**DEPARTMENT OF TRANSPORTATION****Federal Aviation Administration****14 CFR Part 39**

**Airworthiness Directives; Sikorsky Aircraft Corporation Helicopters**

**ACTION:** Supplemental notice of proposed rulemaking (NPRM); reopening of comment period.

**Figure 1-2A to Paragraph (d), Maximum Gross Weight for HEC Requiring Cat 'A'**

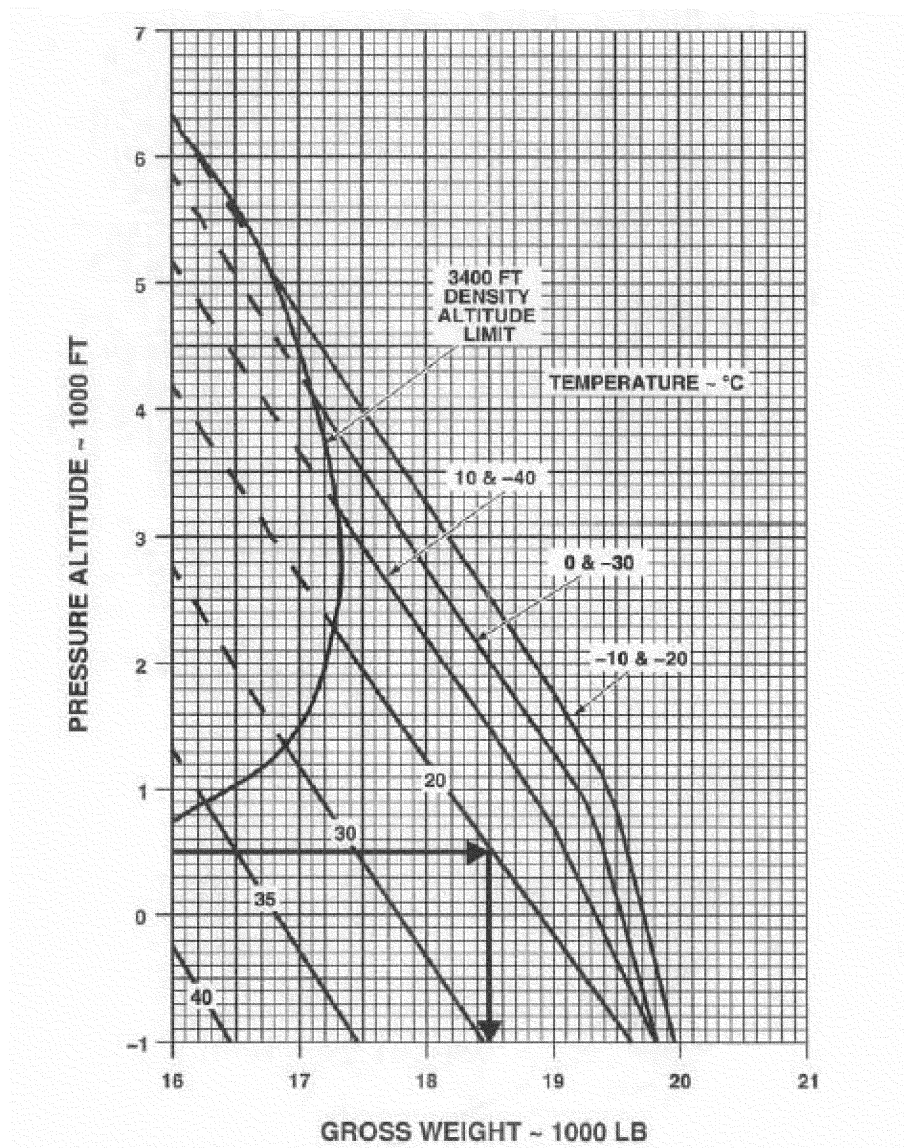
(3) In the Weight Limits section:

(i) Remove this note: “**NOTE:** The 150 pound hoist decrement does not preclude Cat A operations at a gross weight of 26,500

pounds with a hoist installed. If conditions permit, the pilot may go to the right of the 26,500 line on figure 1–2 to determine a maximum gross weight up to 26,650 and then subtract 150 pounds.”

(ii) Add this paragraph and figure: “HOIST Maximum gross weight for Human External Cargo, which requires category ‘A’

performance capabilities, is limited to the gross weight determined in accordance with the following Figure 1–2A to Paragraph (d) of this AD for your altitude and temperature with the air-conditioner, anti-ice, and bleed air turned off.”

**NOTE 1 to Figure 1-2A to Paragraph (d) of this AD: THIS CHART DEPICTS THE GROSS WEIGHT, PRESSURE ALTITUDE, TEMPERATURE COMBINATION WHERE OEI HOGE CAPABILITY EXISTS USING 30 SECOND OEI POWER WITH A 60 SHP MARGIN.**

**NOTE 2 to Figure 1-2A to Paragraph (d) of this AD: 15 FT OF GROUND CLEARANCE IS ASSURED IN THE EVENT OF AN ENGINE FAILURE AT 20 TO 80 FT AGL.**
